HANSON TWEED SAND PLANT EXPANSION PHASE 5 TO PHASE 11

Submission Report

Hanson Tweed Sand Plant Expansion Phase 5 to Phase 11

Figure 6: Existing & Proposed HTSP Footprint (Revised)

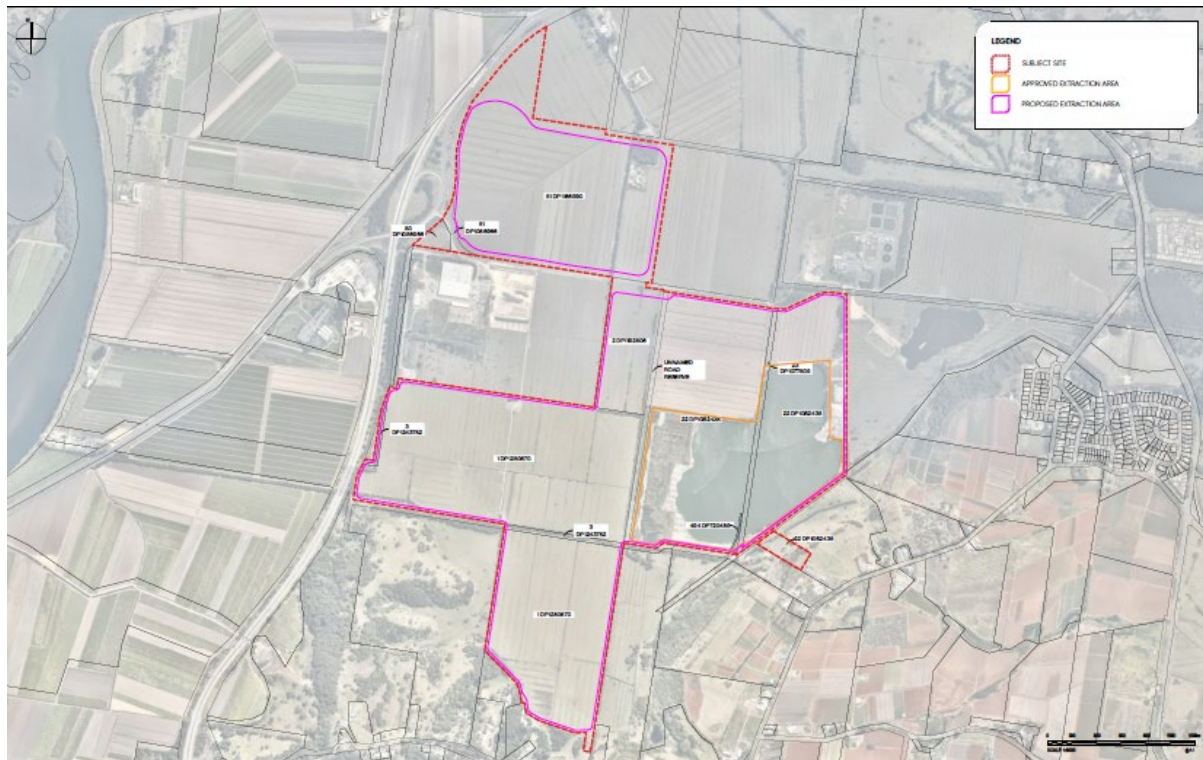
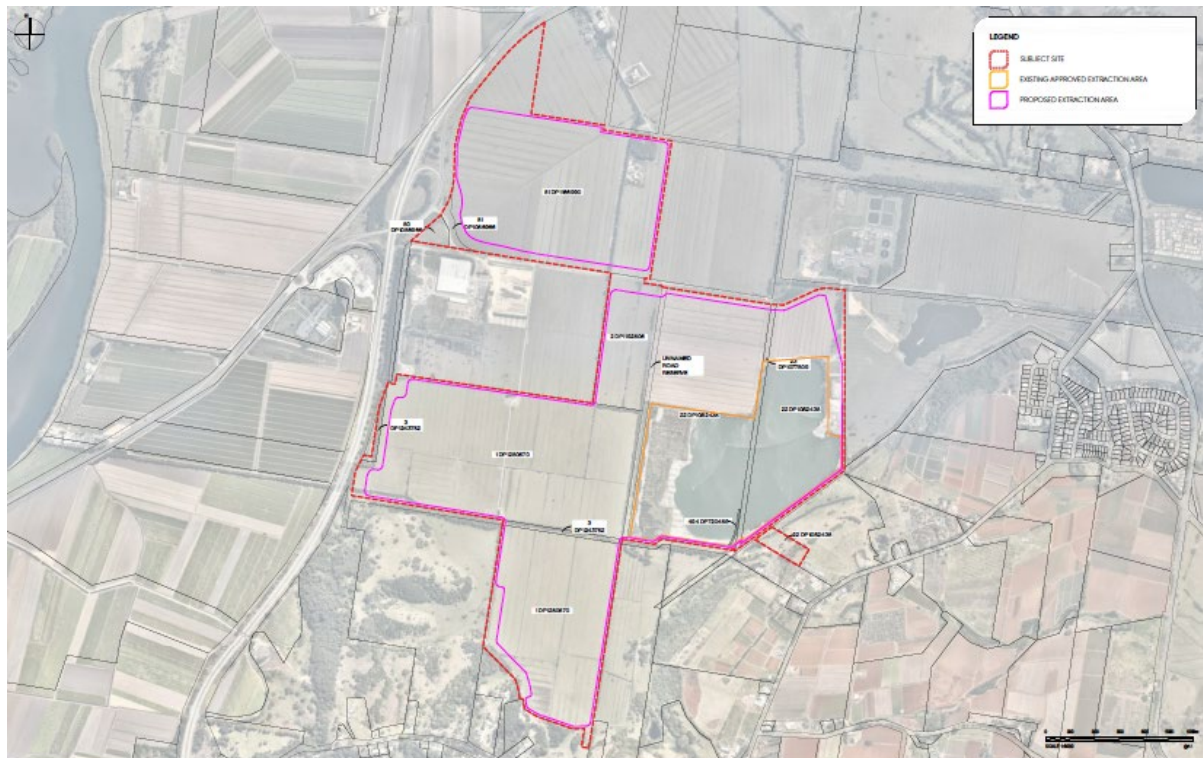
- Reconfiguration of the proposed access to the Tweed Valley Way / M1 Interchange. The access will now be via roundabout rather than a merging slip lane. It is proposed to dedicate land as road reserve as required to facilitate the new roundabout.

- Amendment of the location of the proposed internal haulage route. The internal haulage loop road previously located around the perimeter of Phase 10 & Phase 11 lake has been removed. The haulage route now runs 'centrally' east/west through the Site.

- Commitment to seal the full extent of the internal haulage road.
- Increase the buffer width to Pacific Highway Road Reserve (excluding that part adjacent to the offramp). The buffer to the Pacific Highway Road Reserve is now 50m. The buffer to the part of the road reserve that contains the offramp remains at 10m.

- Inclusion of a 50m buffer adjacent to the offsite groundwater-dependent ecosystem located west of Lot 1 DP1250570.
- Removal of previously proposed lake bunding and revision of stormwater management measures.

- Consequential changes to the lake configuration to incorporate the amended buffers relocated haulage route and revised access to the Tweed Valley Way / M1 Interchange.

Figure 6 identifies the existing HTSP extraction footprint and the proposed expansion footprint.

The project will provide new private haulage road with connection to the Tweed Valley Way / M1 Interchange. **Works to connect to the interchange will see the construction of a new roundabout.** The existing HTSP Phase 1 to 4 haulage route of Altona Road / Crescent Street / Tweed Coast Road will be abandoned, removing all HTSP vehicles from local roads. The existing site buildings and wash plant will remain in use during Phases 5 and 6. The site buildings and wash plant will be relocated to an alternative position onsite from Phase 7 onwards.
